Relay Path Management during Network Entry

(Comments on 6.3.25.2.1 Path Establishment, Removal and Update)

Example 1a: RS1 entering the MR-BS network directly

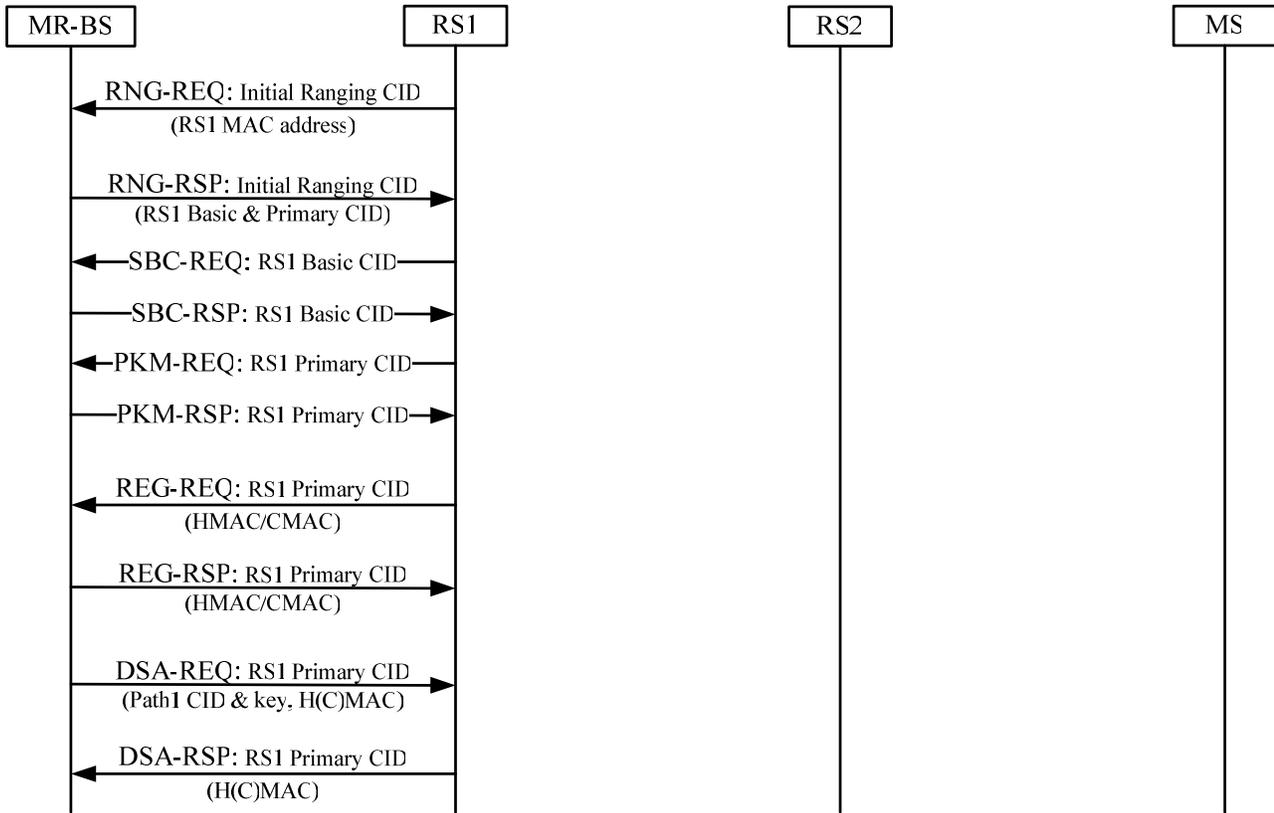
In the MS/RS network entry phase, because the MR-BS shall send the RNG-RSP with success status to the new RS via the selected relay path to complete the ranging process, it is more efficient to piggyback the RNG-RSP message with additional TLVs as the path establishment command instead of using extra DSA/DSD*-REQ messages. In order to elaborate the proposed light-weight relay path management scheme, an example is given as follows, which depicts the path establishment flows of a 3-hop MR network. Moreover, to facilitate the incorporation of this proposal into IEEE 802.16j standard, specific changes to the baseline working document IEEE 802.16j-06/026r3 are listed below.
